City of Hudson residents and stakeholders,

Thank you for the comments received during and after the August 2 Veterans Trail, Phase 3, public meeting. We received many thoughtful questions and comments regarding the project and have assembled a list of questions and answers below. Thank you for your participation in the project.

Example of speed table at narrowing, NACTO Urban Street Design Guide

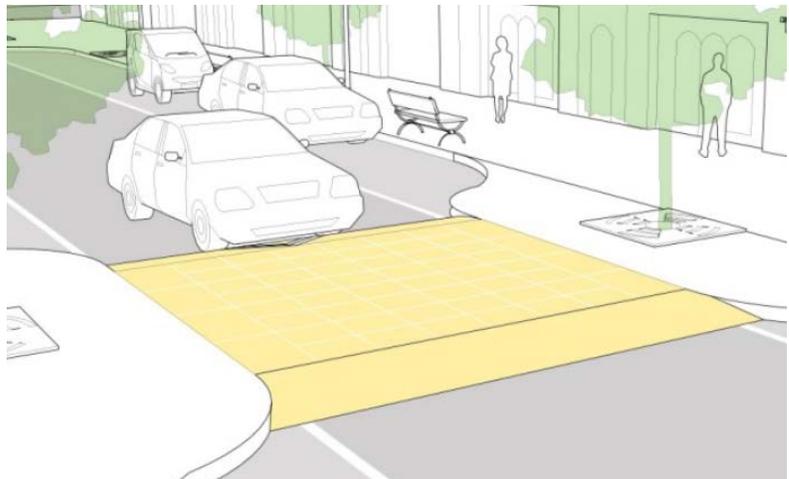
3. Consider increased traffic controls and enforcement along Milford Drive to reduce and slow traffic to the posted speed limit. The City should consider traffic calming measures along the "cut-through" route between SR 303 and Veterans Way.

The existing traffic calming (narrowed roadway width) on Milford will be maintained. To more effectively slow motorists, the roadway will be raised at the narrow point to create a speed table. The speed table is designed to reduce motorists' speeds and facilitate the merging of bicycle and motor vehicle traffic to navigate the narrow point. See graphic below for an example of a speed table.
